Sundry Print Report

Well Name: JIC APACHE I

Type of Submission: Notice of Intent

Type of Action: Plug and Abandonment

Proposed Wellbore Diagram

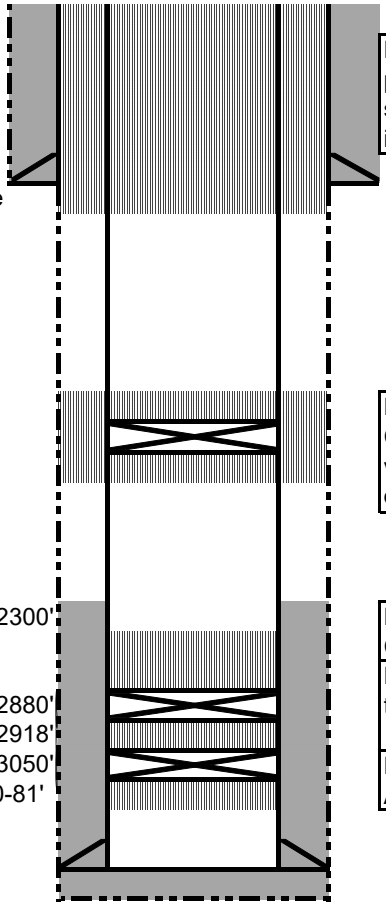
You are also required to place cement excesses per 4.2 and 4.4 of the attached General Requirements.

K. Rennick 6/29/2022

Plug 5: Surface casing shoe and surface plug: Perf holes at 186'. Mix and pump sufficient volume to bring cement to surface, inside and outside.

Plug 4: Nacimiento: Perf holes at 2018'. Set CR near 1968'. Mix and pump sufficient volume to bring TOC to 1918', inside and outside.

Plug 3: Ojo Alamo: Spot blind plug on top of CR to bring TOC to 2587'.

Plug 2: *Kirtland: Set CR near 2880'. Attempt to pump 10 sx through CR. Run CBL.

Plug 1: Pictured Cliffs: Set CR near 3050'. Attempt to pump 10 sx cement through CR.
